The purpose of this letter is to respond to your February 6, 2003 letter concerning issues related to proper sealing and inerting of Multi-Canister Overpacks (MCO) at the Hanford Spent Nuclear Fuel Project. The attached report from the Hanford Site addresses your concerns on the following:

SUBJECT: HANFORD SPENT NUCLEAR FUEL (SNF) PROJECT MULTI-CANISTER
OVERPACK (MCO) WELDING

ATTACHMENT 2
Relaxation of the MCO Shield Plug Gasket
Due to Lifting and Handling at the CSB

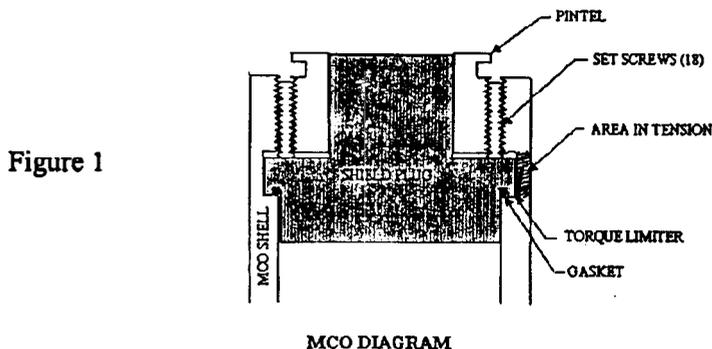
- Proper sealing/inerting of MCOs prior to welding,
- Lifting stresses on mechanical seals during movement of the canisters have received proper analyses, and
- The disposition of previously welded MCOs is satisfactory.

During closure, a shield plug is pressed into the MCO with 150,000 lbs of force by a hydraulic ram to crush the gasket and make a seal. The torque limiter limits gasket compression to the prescribed amount. The shield plug is held in place by 18 set screws, which maintain the preload on the gasket after the ram is removed. The top of the MCO contains a pintel by which it is lifted. The pintel is part of the locking ring, which is attached to the MCO shell by a buttress thread, and forms a single component for this stress analysis. This threaded joint is not shown for clarity. See Figure 1 for a schematic representation.
